**MONTGOMERY COUNTY HISTORIC PRESERVATION COMMISSION**  
**STAFF REPORT**

<b>Address:</b>	23 Columbia Ave., Takoma Park	<b>Meeting Date:</b>	3/27/2019
<b>Resource:</b>	Contributing Resource <b>Takoma Park Historic District</b>	<b>Report Date:</b>	3/20/2019
<b>Applicant:</b>	Ruth & Karl Pitt Rick Vitullo, Architect	<b>Public Notice:</b>	3/13/2019
<b>Review:</b>	HAWP	<b>Tax Credit:</b>	n/a
<b>Case Number:</b>	37/03-19H	<b>Staff:</b>	Dan Bruechert
<b>Proposal:</b>	Garage Construction, New Windows, and Door

HICKORY AVENUE  
 PROPOSED SITE PLAN

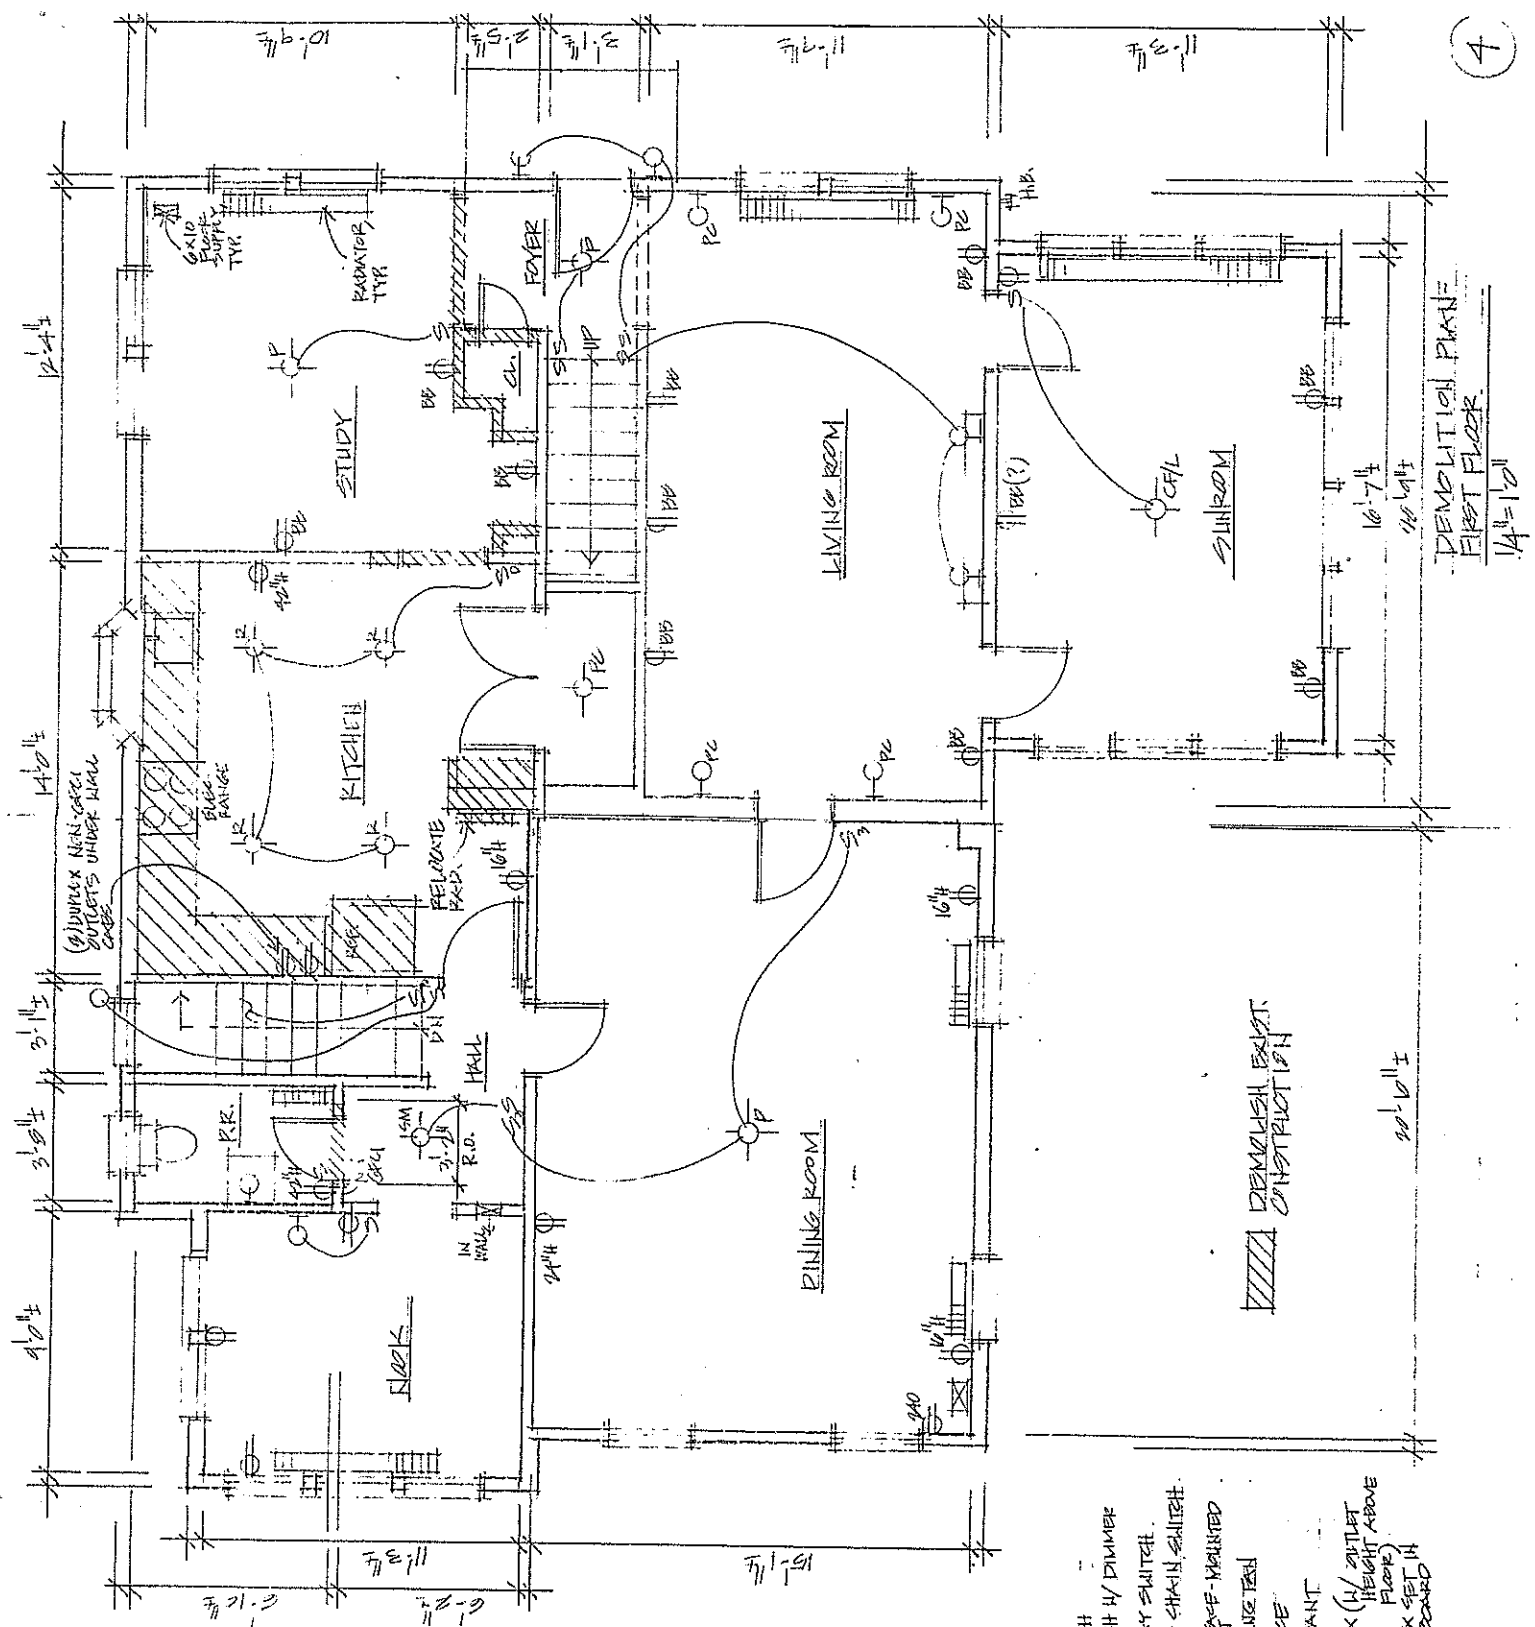
The applicant initially proposed to construct a series of new walkways, a parking pad, hardscaping, and a pedestrian ramp on the site. These elements have been removed from the scope of work and are not under consideration as part of this HAWP. The permit drawings submitted will not include these elements. A future HAWP will likely be submitted for this

PROPOSED FIRST FLOOR PLAN  
1/4" = 1'-0"

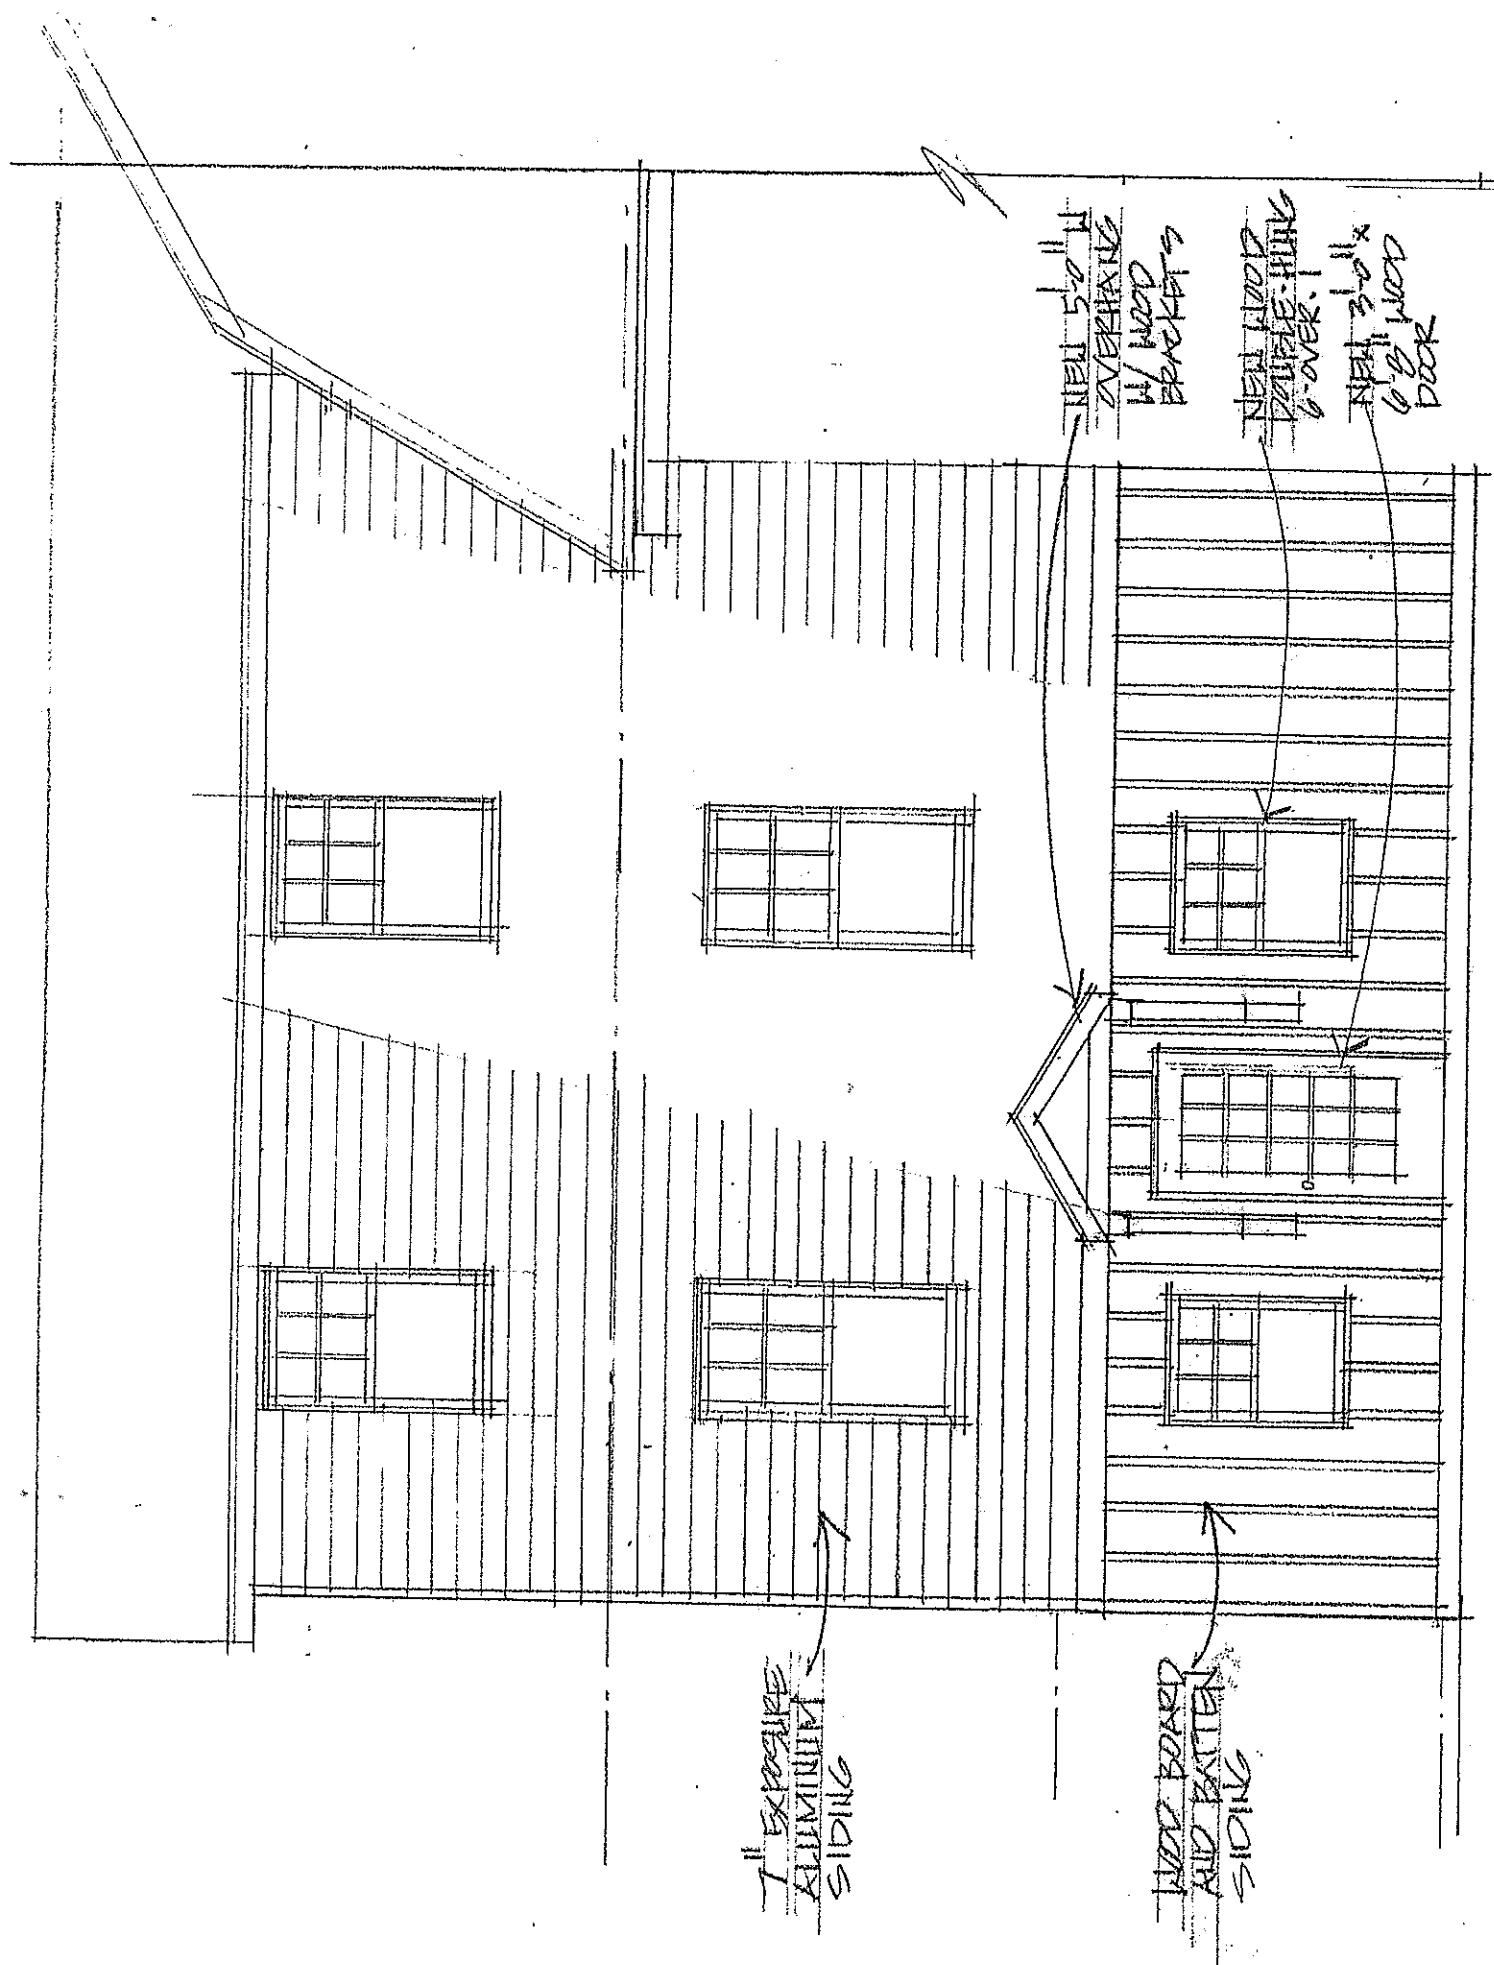
On the west elevation there is a non-historic aluminum bay window installed on the first floor. This feature is minimally visible from the public right-of-way due to the narrow setback of the neighboring house and the mature landscape.

The applicant proposes to install two new, painted wood casement windows in this location. Staff finds that while a sash window would be more appropriate in this location, casement windows are appropriate in this instance, because it is filling in a non-historic opening and because the window is removed from the streetscape so that the change will not be highly visible from the public right-of-way. Staff supports approval of the window removal and replacement in this location.

PROPOSED HICKORY AVE. ELEVATION

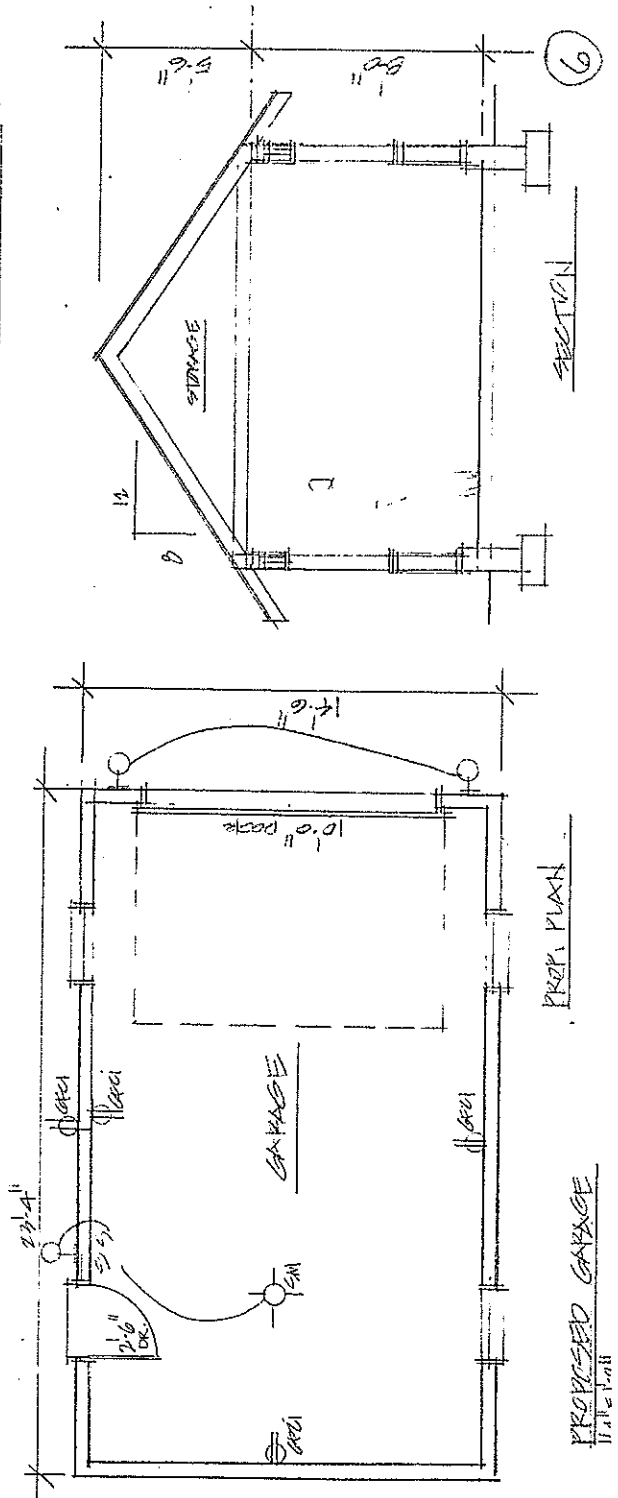
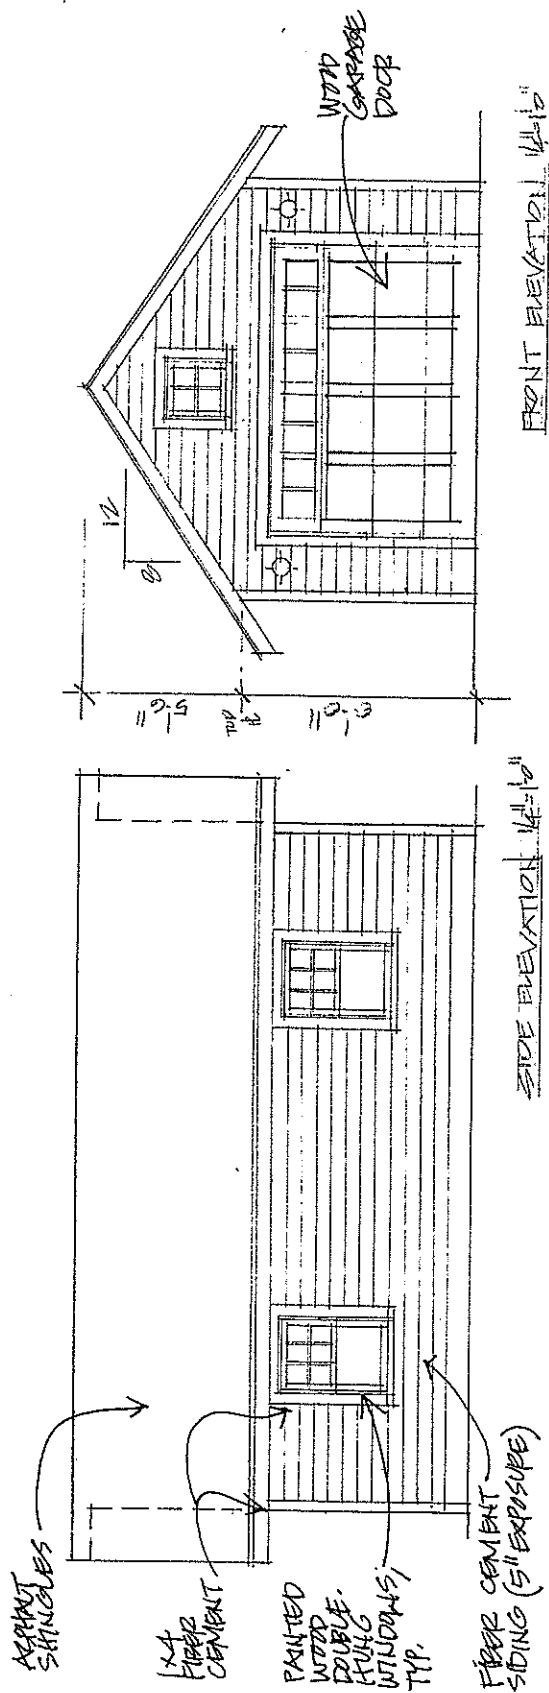
The applicant proposes to reconfigure fenestration in the southwest corner of the rear addition. The applicant proposes to place the door in the middle flanked by a six-over-one windows. The new entrance will be covered by a wood, triangle pediment with wood brackets, similar in size to the existing overhang. The new window will be a wood, six-over-one window that matches the size and appearance of the existing window.

Staff finds that this will be a minor modification to the existing fenestration. Per the design guidelines, this alteration is generally consistent with the predominant architectural style of the house and Staff recommends approval of this change.

GARAGE FRONT

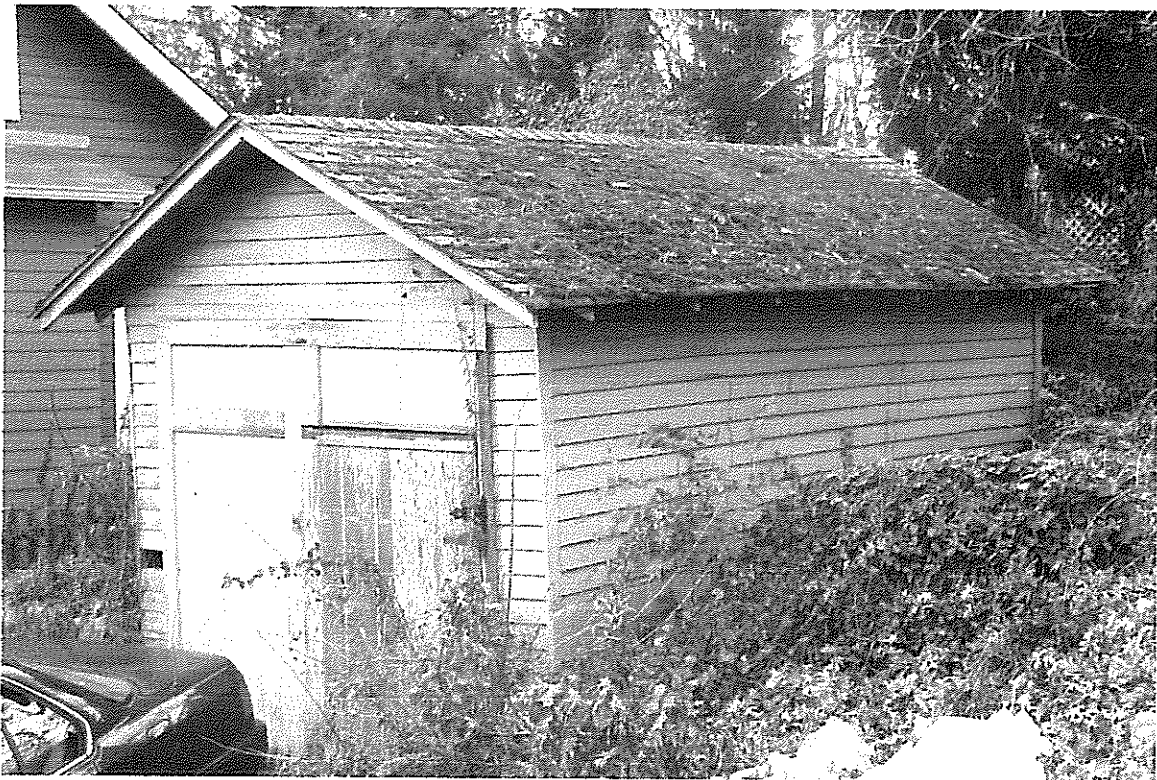
The applicant proposes to construct a new, one-bay, garage in the same location as the original structure on a new concrete foundation. The new garage will be 14' 6" × 23' 4" (fourteen feet, six inches by twenty-three feet, four inches). The siding will be fiber cement in a 5" reveal. The gable roof will be covered in asphalt shingles. And the garage door will be a wood, roll-up, door with windows above. There will be two, wood, six-over-one windows along the long side of the garage.

Staff finds that the new garage is in keeping with the historic character of the site, house, and surrounding district. The HPC has consistently approved fiber cement for contributing resources on new construction within the Takoma Park Historic District. Staff finds this to be an appropriate use of this material and it will not detract from the historic character of the house or surrounding district. The remainder of the materials, i.e. wood windows, asphalt shingles, concrete slab, etc. are all consistent with the materials used historically for detached garages in this period of construction.

Staff finds that the placement of a garage in this location is appropriate and that the design, materials, and details are all consistent with the historic character of the house and surrounding district and recommends approval.
